Access Compliance Report

Public Rights-of-Way

(Curb Ramps)

Intersection ID: 7024	Main Street: TILDEN_RD	Cross Street: WHITLOCK_DR	Location: S
ADA ID: 14454B3AD1A7	Ramp Type: Perp	Initial Pass/Fail: Fail	Overall Compliance: No
		Severity Score: 1.25

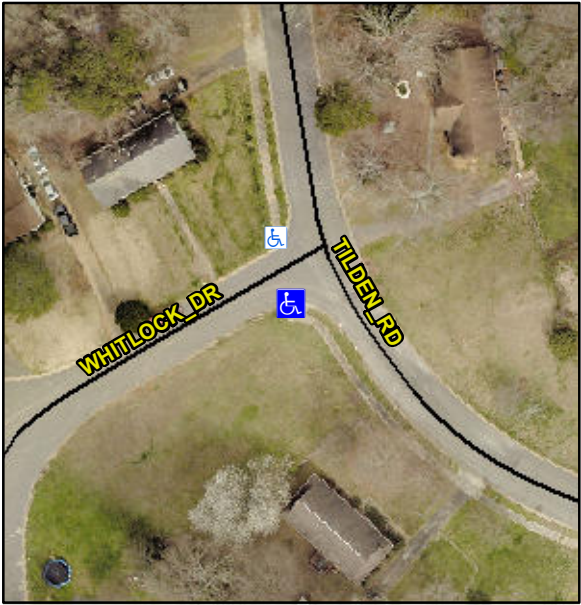
Codes/Mitigation Info/Possible Solution			Field Measurements/Component Compliance		
	Possible Solutions:		Compliance	Description	Data
	Remove & Replace Entire Ramp.		N/A	Ramp Length (in)	48.0
			Yes	Ramp Width (in)	48.0
			N/A	Flare Type LT	N/A
			N/A	Flare Slope LT (%)	N/A
			N/A	Flare Traversable LT?	N/A
			N/A	Landing Length (in)	N/A
			N/A	Landing Width (in)	N/A
			N/A	Landing Slope (%)	N/A
			N/A	Landing X Slope (%)	N/A
<p>Surveyor Notes:</p> <p>N/A</p> <p>PROW/ADA:</p> <p>R304.5.3</p>			N/A	Flare Type RT	N/A
			N/A	Flare Slope RT (%)	N/A
			N/A	Flare Traversable RT?	N/A
			N/A	DWS Provided?	N/A
			N/A	DWS Contrast?	N/A
			N/A	DWS Length (in)	N/A
			N/A	DWS Full Width?	N/A
			N/A	DWS Offset (in)	N/A
			N/A	Gutter Ponding?	N/A
			N/A	Gutter Lip Ht (in)	0.5
			N/A	Painted X Walk1?	No
				X Walk 1 Direction	To N
			N/A	X Walk 1 Width (in)	N/A
				X Walk 1 Slope (%)	2.1
				X Walk 1 X Slope (%)	6.0
			N/A	Ramp inside XWalk1?	N/A
